Addendum No. 3
Juniper Hill Road 19" Main Replacement
PWP Bid No.: WA-2017-013
TMWA Capital Project No.: 10-0001.038
November 30, 2016

The following information, clarifications, changes and modifications are by reference incorporated into the bid documents for the above referenced project. Any work item or contract provision not changed or modified will remain in full force and effect.

C3

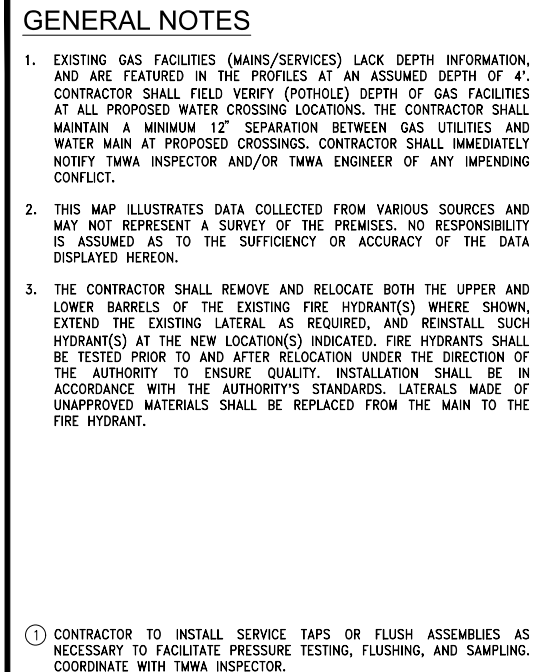
Question No. 1: Please clarify what is required at Sta 0+00 for the tie-in of the new 12" main to the existing 18" main in Mayberry. A tapping sleeve or a weld-on saddle could be used for a hot tap according what the existing pipe material is. The plan note "Ductile Iron MRJ Tee" is not clear to me. If a flanged tee is used with FCA's on the 18" main, it would require shut down and dewatering of the main which doesn't seem practical.

Question No. 2: What is meant by the note at Sta 0+00 "12" Dia MRJ Gate Valve for 75'"? Does this 75' designate footage of 12" pipeline to be restrained? Also reference to Detail 10B-2 doesn't appear to apply to what is called out on the plan. Detail shows two valves and adapter on tee.

Question No. 3: At Sta 0+05.68, reference is to Detail 10L-2 for the 22-1/2 degree elbow. That detail is for a Push-On elbow. Is that correct or should it be an MJ elbow with megalug restraints?

Response to Question No. 1: The connection detail at Mayberry Drive has been revised. See the updated set of Improvement Drawings (attached to this addendum) for further information.

Response to Question No. 2: This item has been clarified in the revised Improvement Plans.

Response to Question No. 3: The specific design takes precedence over standard details. Therefore, the fitting in question shall be restrained. This applies to other fittings with similar callouts as well.

C5

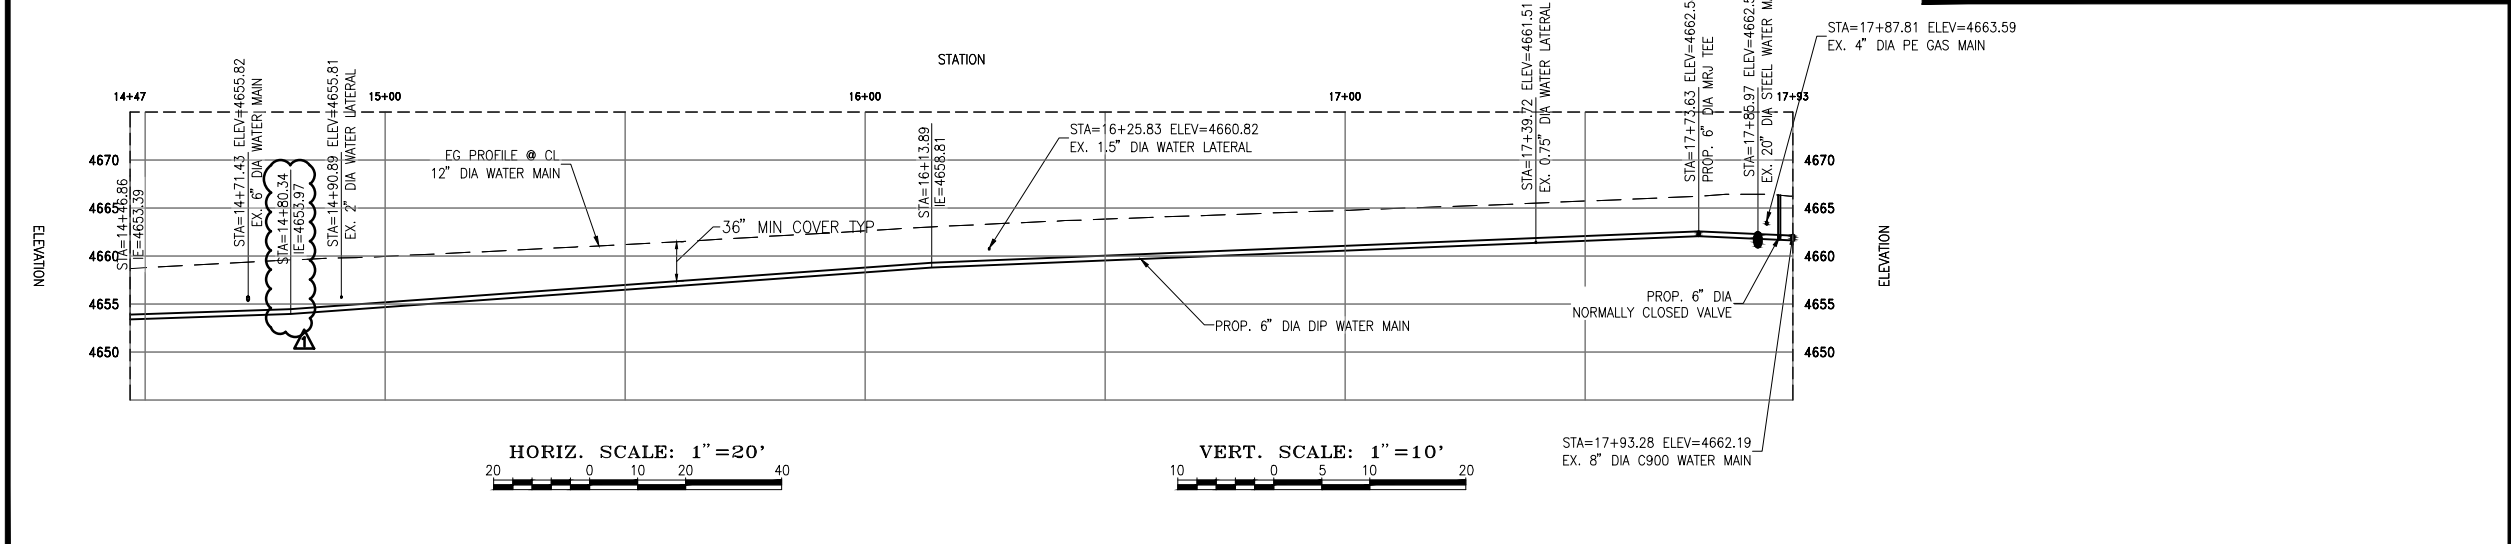
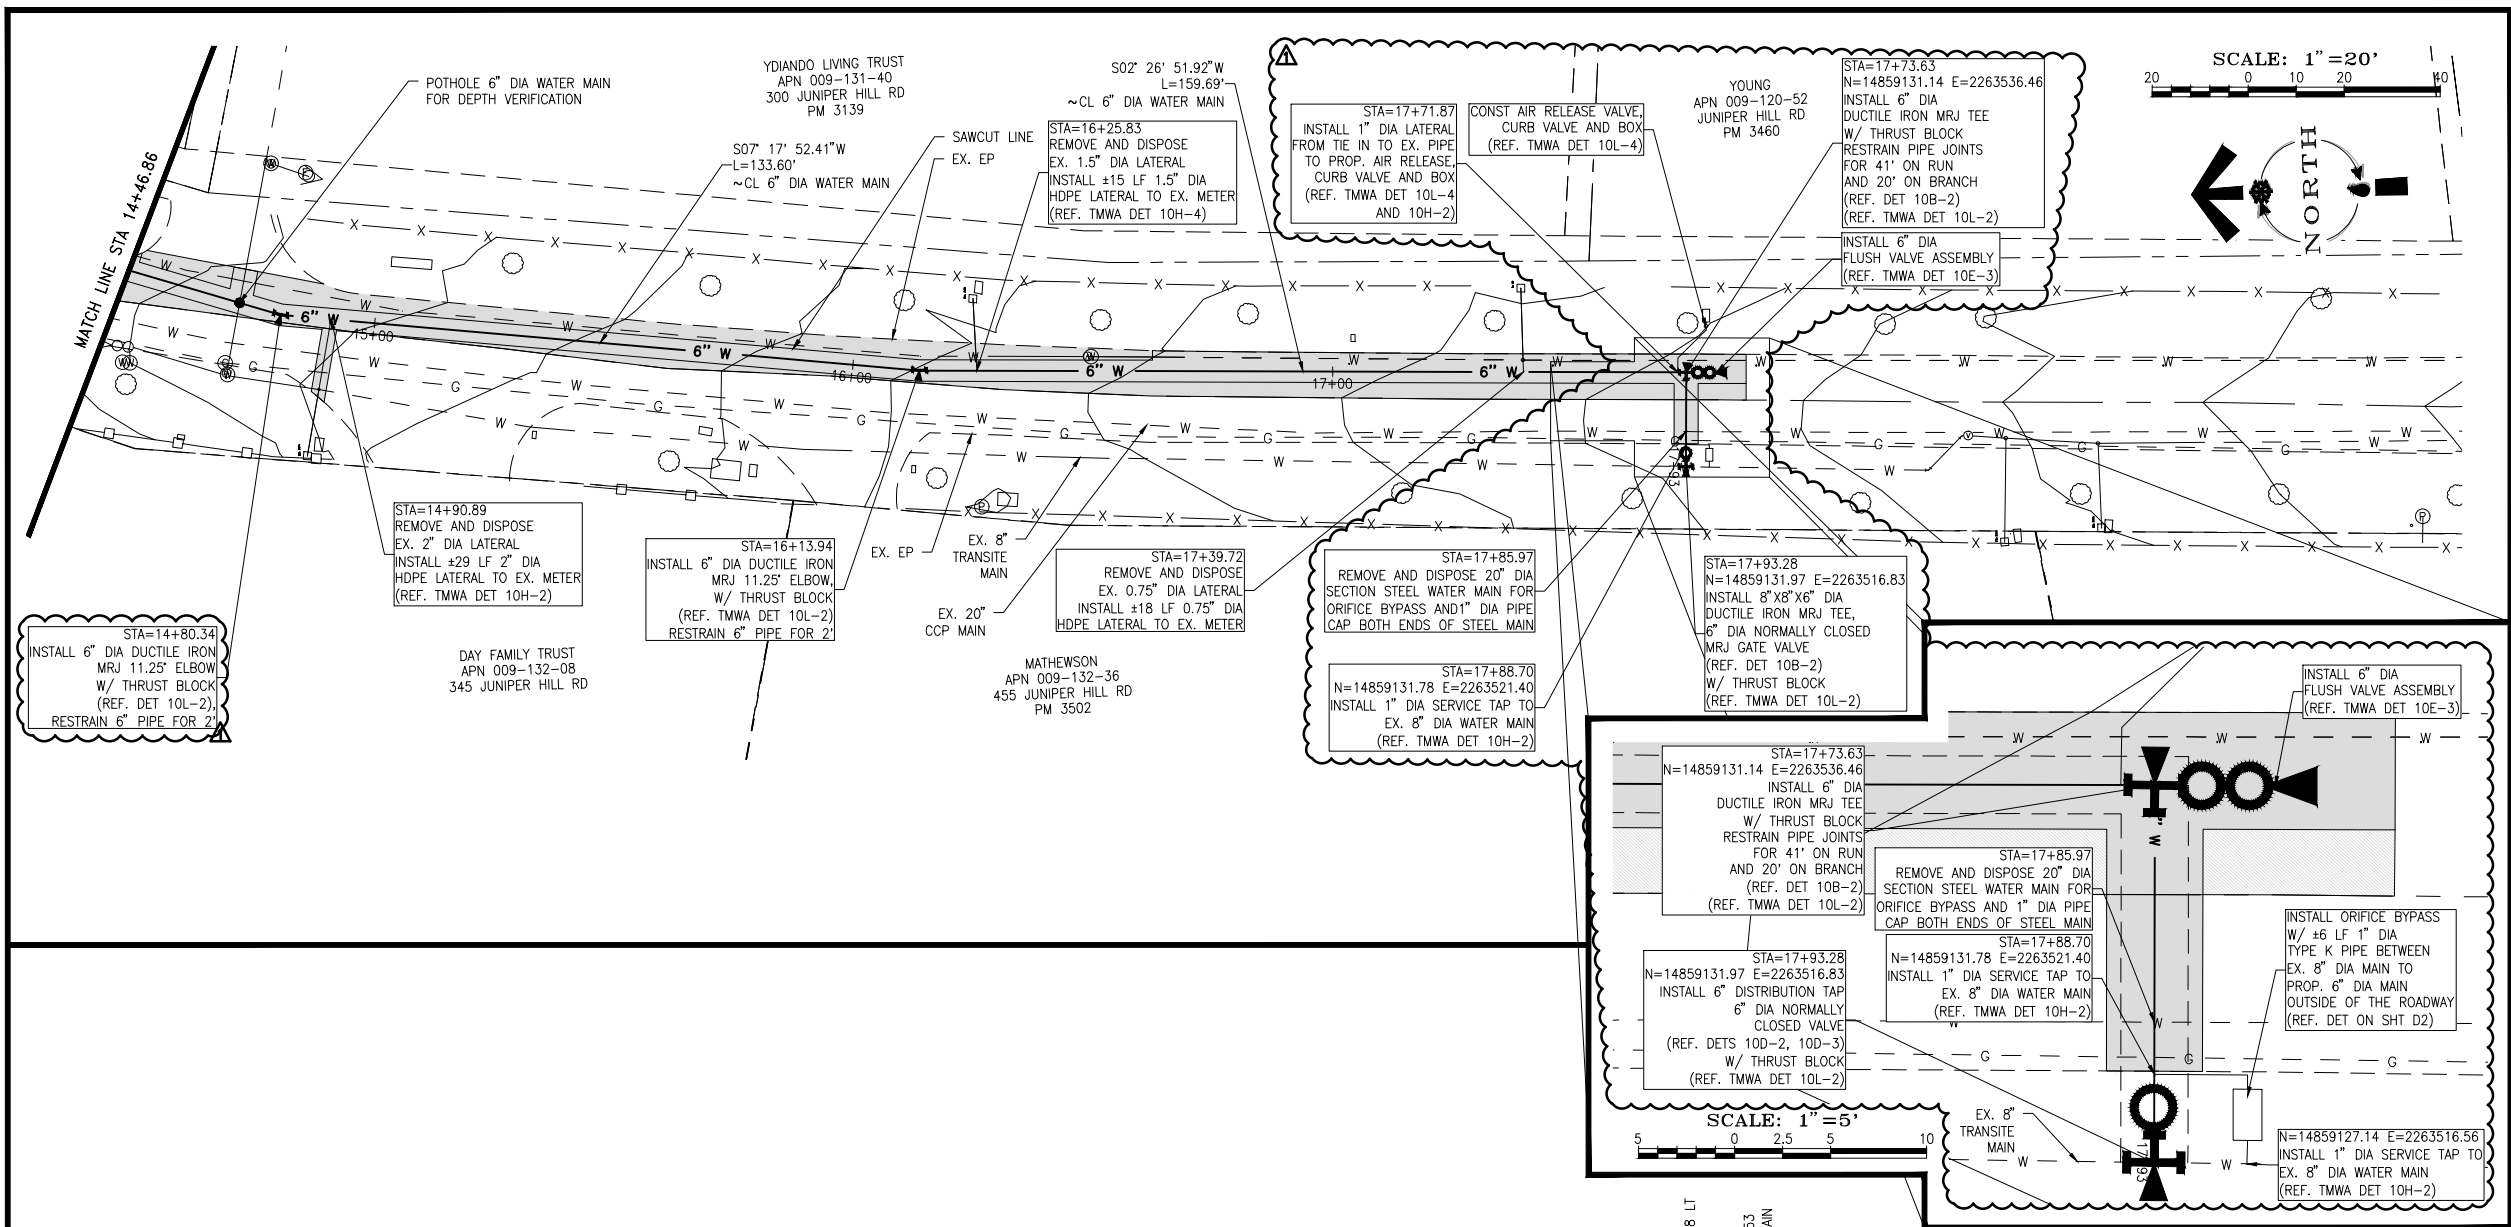
Question No. 5: Detail on Sheet D2 for Hydrant/Fire Service Reconnect shows 6" DIP typical at fire hydrants. Notes on Sheets C3 and C5 call for 6" PVC for the hydrant laterals.

Is the correct lateral pipe to be DIP or PVC? The detail also calls for 6" MRJ gate valves on the laterals whereas TMWA standard is for PO x FL Gate Valves with restraint provided by thrust blocks at the tee and hydrant.

Question No. 6: What type of pipe is existing at Stations 9+00 and 9+85.59? MJ sleeves or EBAA 3800 coupling could be used if DIP or C900 exists and if it is AC pipe, it could be connected with Hymax couplings and require thrust blocks for restraint. Please clarify.

Response to Question No. 5: This item has been clarified in the revised Improvement Plans.

Response to Question No. 6: This item has been clarified in the revised Improvement Plans.

SHEET NUMBER
C6
7 OF 13

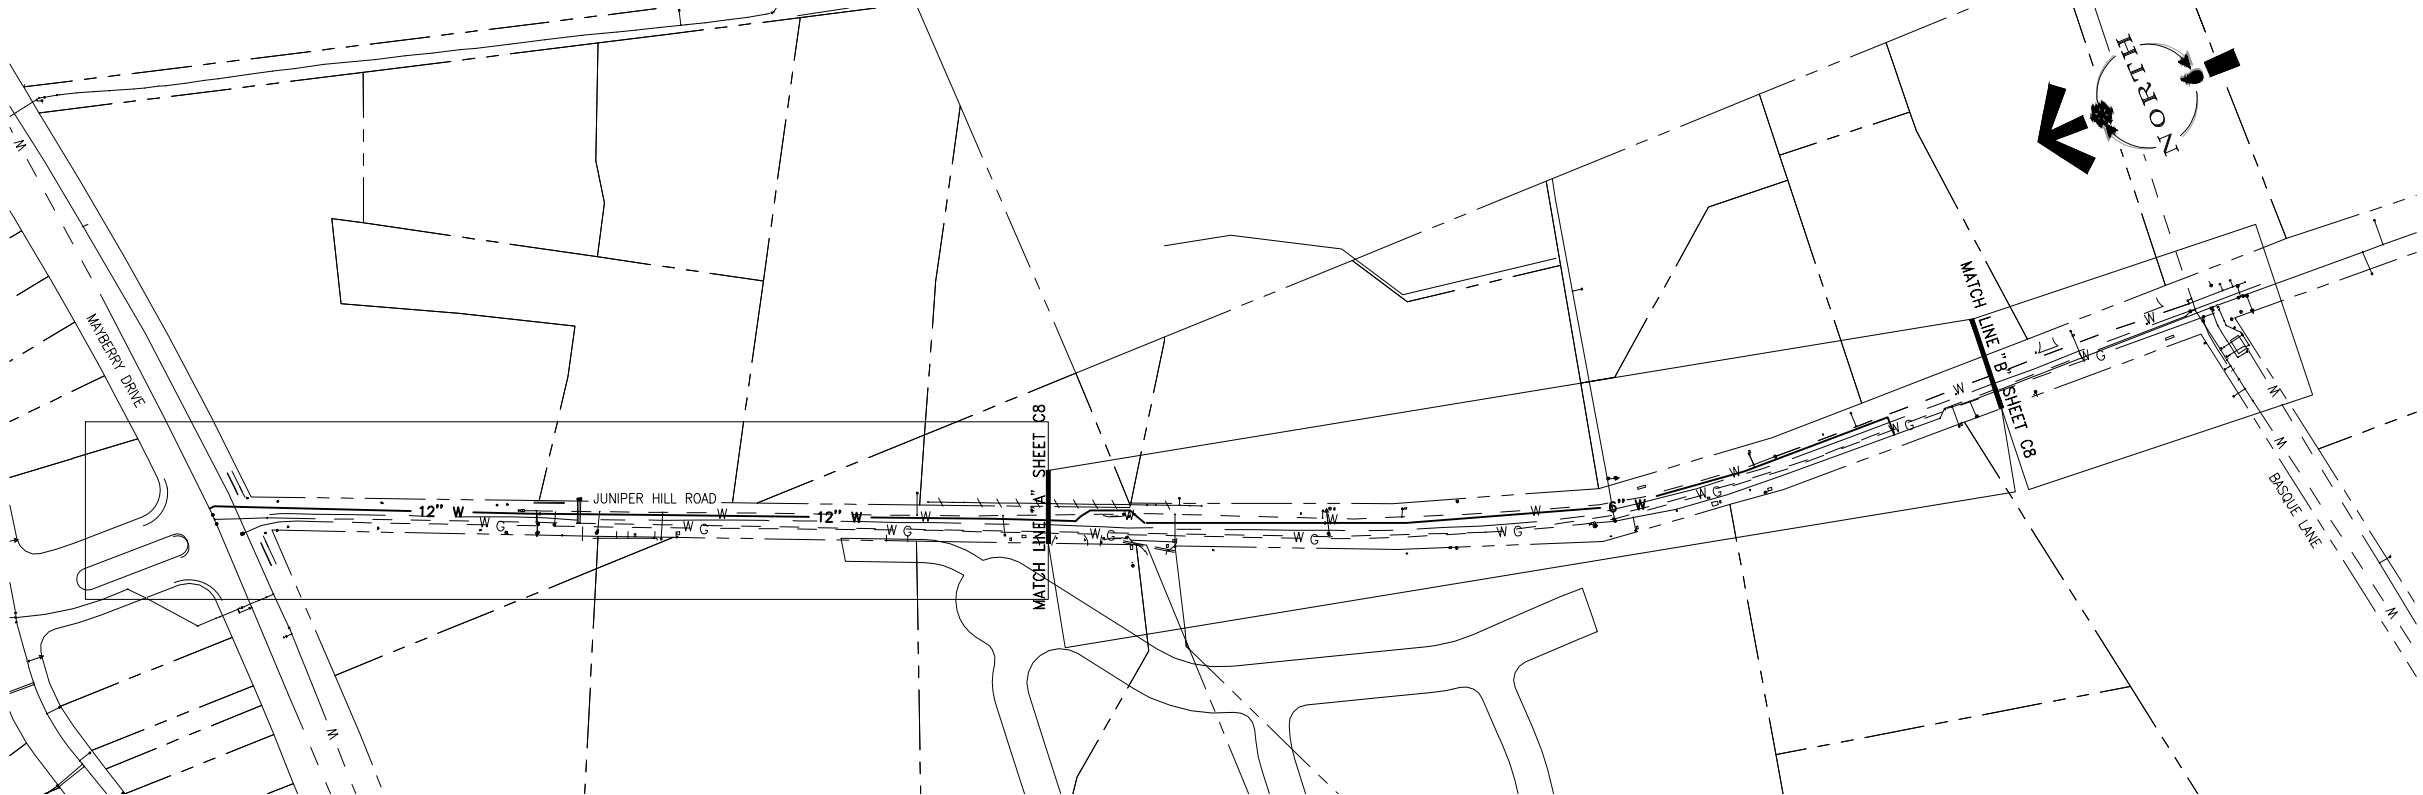
Question No. 7: At Station 14+71.43, a 6" tee and two 6" gate valves are called out with 27' of restrained 6" pipe. Is the pipe to be DIP or PVC? The upper note has an arrow to the valve for the tie-in to existing, but 27' would be to the existing fire hydrant above. Please clarify connection requirement.

Question No. 9: The blown up detail on plan sheet C6 is confusing. At Station 17+73.63, a 1" service tap is called for to run 20' of copper from the new 6" main through the orifice bypass to the existing 8" main. However, the detail shows a 6" W for that line with a large circle which would seem to designate a gate valve. At this station on the profile, a 6" MRJ tee is called out. The 6" main would appear to terminate at the flush valve assembly. Please clarify all of this.

Response to Question No. 7: This item has been clarified in the revised Improvement Plans.

Response to Question No. 9: This item has been clarified in the revised Improvement Plans.

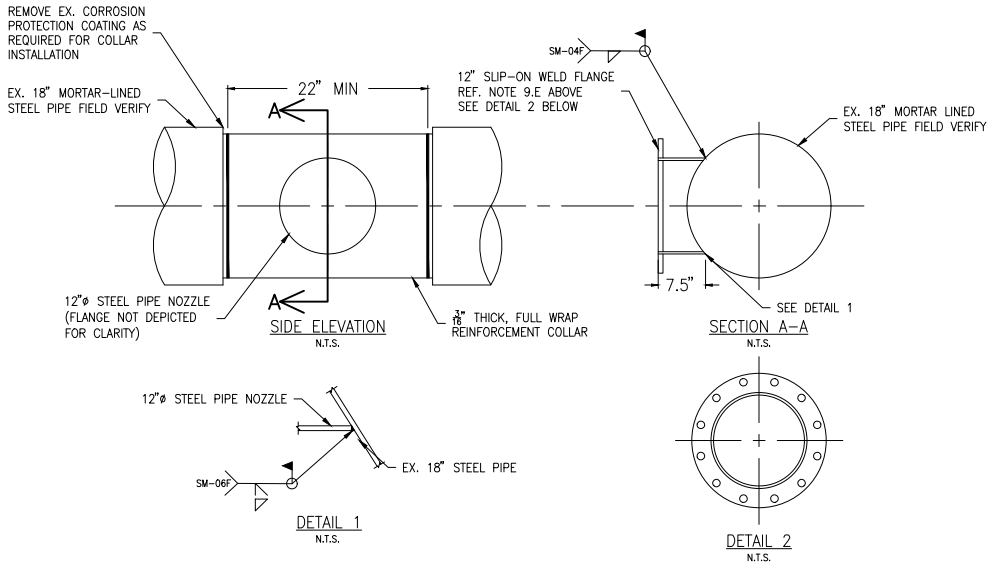
Question No. 14: Also if the 18" existing is OD steel an MJ tee won't work?

Response to Question No. 14: The connection detail at Mayberry Drive has been revised. See the updated set of Improvement Drawings for further information.
